The Oaks at the Colony

Presentation to the Baldwin County Commission

July 5, 2023

Conceptual Master Plan

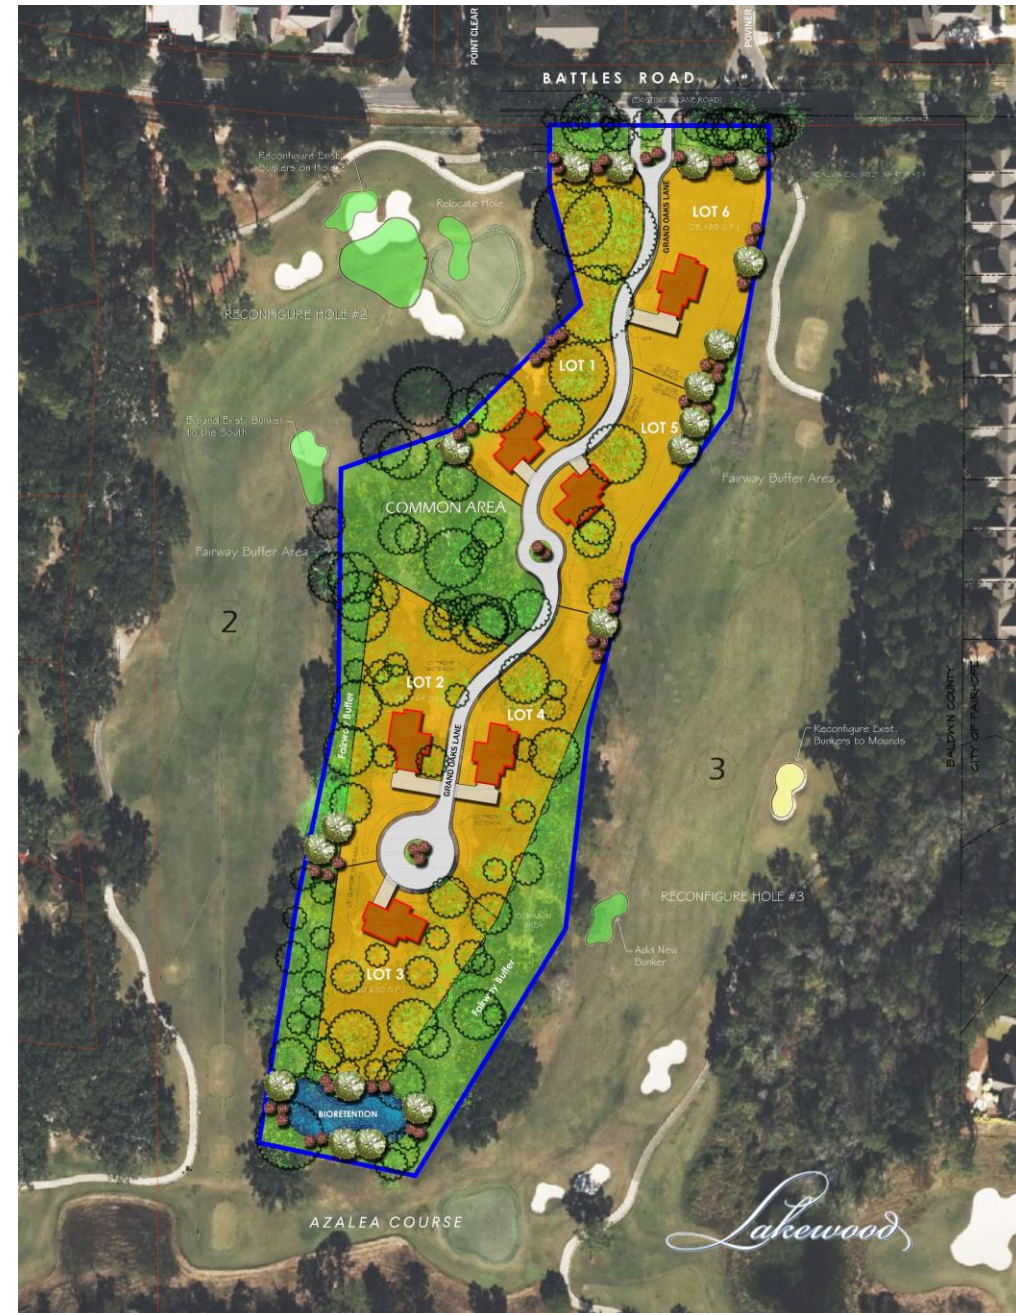
I was contacted by RSA representatives to review a proposed sketch plan for six homesites on 7.2 acres located between golf holes 2 & 3 of the Azalea Course at the Lakewood Club, in order to determine whether the design and layout met appropriate best practices for residential developments adjoining golf courses. The sketch plan is identified as "THE OAKS AT THE COLONY" and prepared by GMC.

Applying the data from Broadie's book to the Oaks, the lot locations of the homesites in the Oaks (all of which are outside the 175-foot corridor) would avoid encroachment from errant tee shots from the White tee approximately 98.25% of the time.

Homesite 1: Based on the relocation of the 2nd green as shown on GMC's plan, this homesite has very little risk of having a golf ball enter the lot due to the distance from the green and the fact that

Homesite 2: This homesite has a very low risk of errant shots

Homesite 3: This homesite is low risk

Homesite 4: This homesite is located to the right of golf hole 3 and is positioned opposite the landing area for almost all golfers. This homesite has a very low risk of errant shots as it is the

Homesite 5: This homesite is located midway between the tees and the landing area of the golf hole. It is the appropriate distance from the third golf hole and therefore a very low risk factor.

Homesite 6: This homesite is located to the right of the back three tees of the third hole and has very little to no chance of being impacted by an errant golf shot.

Broadie Scatter—Plot of High Handicap Golfers
GOLF HOLE 2
THE AZALEA COURSE AT LAKEWOOD GOLF CLUB

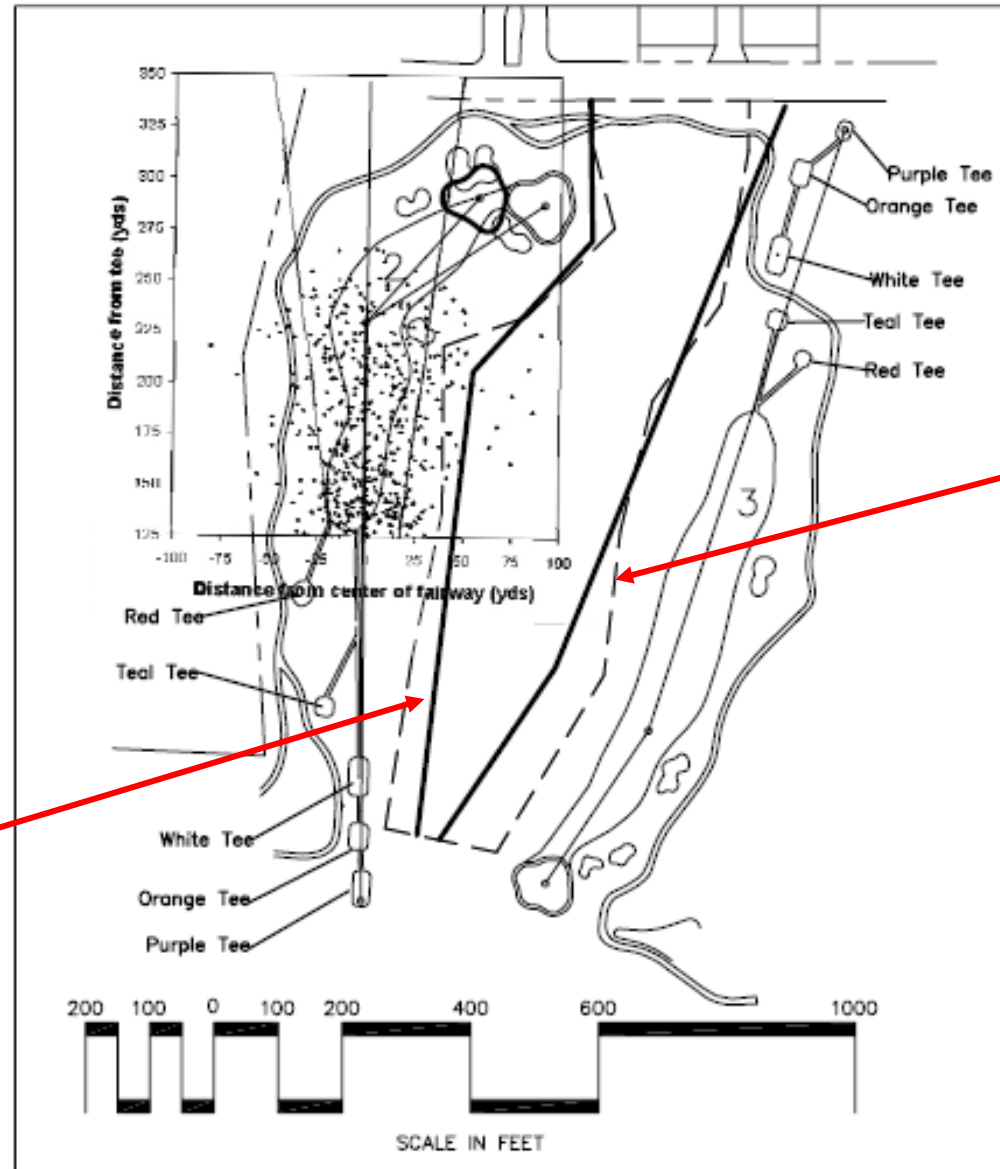
6. Assuming that Broadie's paper utilized an average cross section of golfers and incorporated unique features of Azalea Holes two and three (it does not), I have attached properly scaled overlays of the Broadie scatter plot using the correct hole locations, aiming lines and middle teeing grounds for both golf holes. Instead of Google Earth, I utilized AutoCad software, which is based on an accurate site survey of the area to create my overlays. As my overlays plainly demonstrate, Mr. Tannar's projections regarding the numbers of errant golf balls in the proposed development area are clearly false.

Scatter plot showing 500 shots of high-handicap golfers only (from Broadie).

Fairway #2.

Broadie Scatter-Plot of High Handicap Golfers
GOLF HOLE 3
THE AZALEA COURSE AT LAKEWOOD GOLF CLUB

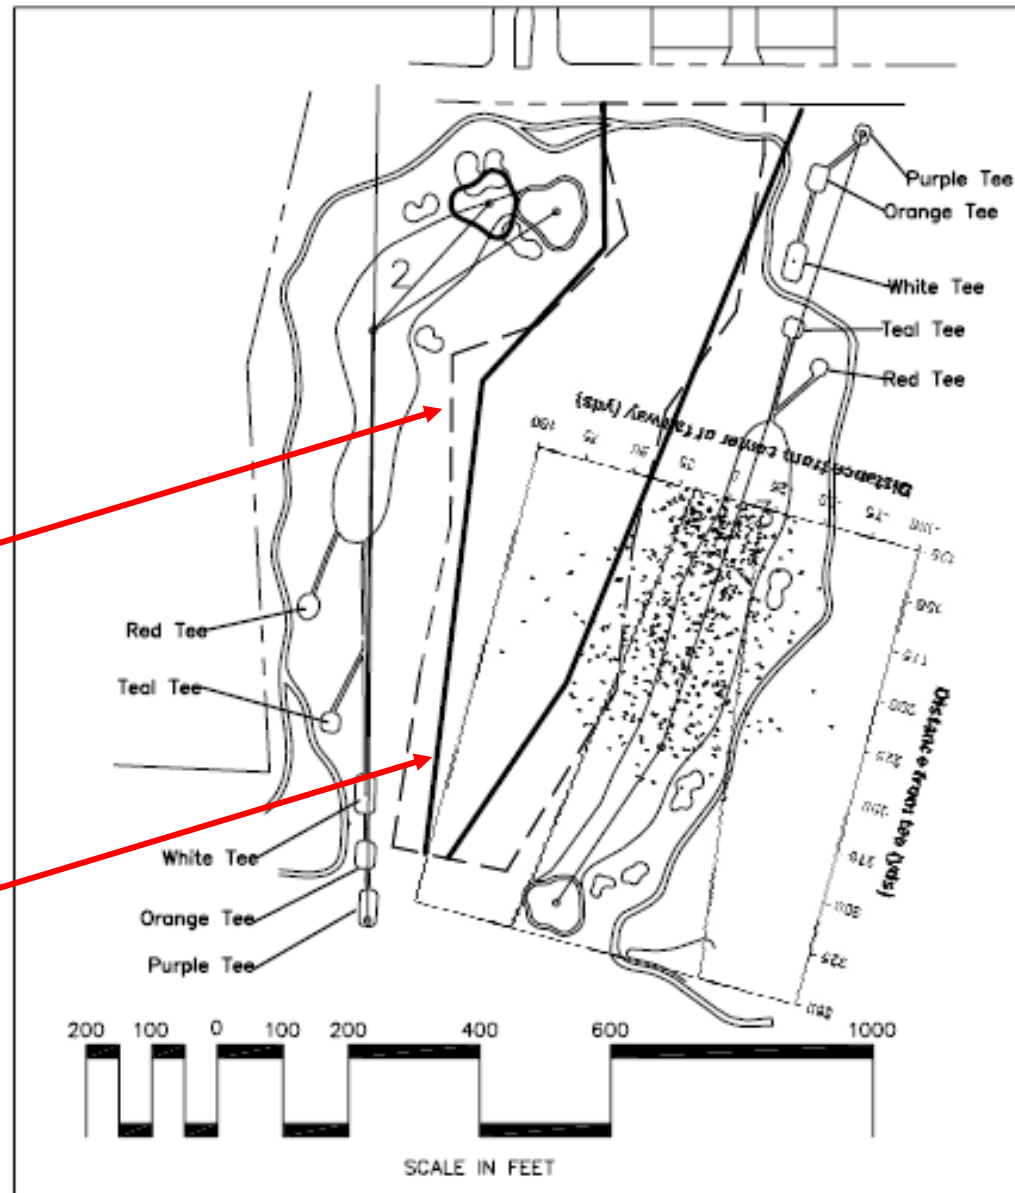
Scatter plot showing
500 shots of high-
handicap golfers only
(from Broadie).

Fairway #3.
